Access Compliance Report

Public Rights-of-Way

Intersection ID: N/A	Main Street: TAMARACK DR	Cross Street: SINGLELEAF LN	Location: NE
ADA ID: 486D0F05C407	Ramp Type: Perp	Initial Pass/Fail: Fail	Overall Compliance: No
		Severity Score: 10

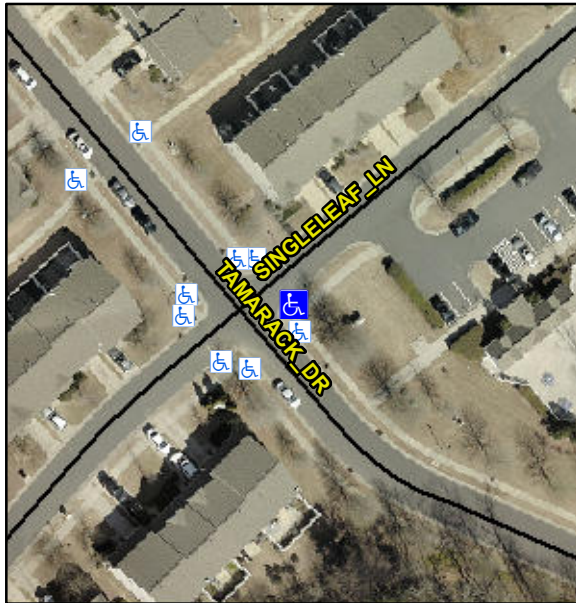
Not Found, R304.5.1, R304.5.3

Compliance	Description	Data	Compliance	Description	Data
N/A	Ramp Length (in)	48.0	Yes	Ramp Slope (%)	7.2
No	Ramp Width (in)	45.0	No	Ramp XSlope (%)	2.7
N/A	Flare Type LT	N/A	N/A	Flare Type RT	N/A
N/A	Flare Slope LT (%)	N/A	N/A	Flare Slope RT (%)	N/A
N/A	Flare Traversable LT?	No	N/A	Flare Traversable RT?	No
N/A	Landing Length (in)	N/A	N/A	DWS Provided?	N/A
N/A	Landing Width (in)	N/A	N/A	DWS Contrast?	N/A
N/A	Landing Slope (%)	N/A	N/A	DWS Length (in)	N/A
N/A	Landing X Slope (%)	N/A	N/A	DWS Full Width?	N/A
N/A	Landing Curb? (Y/N)	N/A	N/A	DWS Offset (in)	N/A
N/A	Shared Landing?	N/A			
N/A	Gutter Ponding?	N/A	N/A	Gutter Slope (%)	N/A
N/A	Gutter Lip Ht (in)	N/A	N/A	Gutter X Slope (%)	N/A
N/A	Painted X Walk1?	No	N/A	Painted X Walk2?	N/A
	X Walk 1 Direction	To NW		X Walk 2 Direction	N/A
N/A	X Walk 1 Width (in)	N/A	N/A	X Walk 2 Width (in)	N/A
	X Walk 1 Slope (%)	0.9		X Walk 2 Slope (%)	N/A
	X Walk 1 X Slope (%)	0.6		X Walk 2 X Slope (%)	N/A

Remove & Replace Entire Ramp.
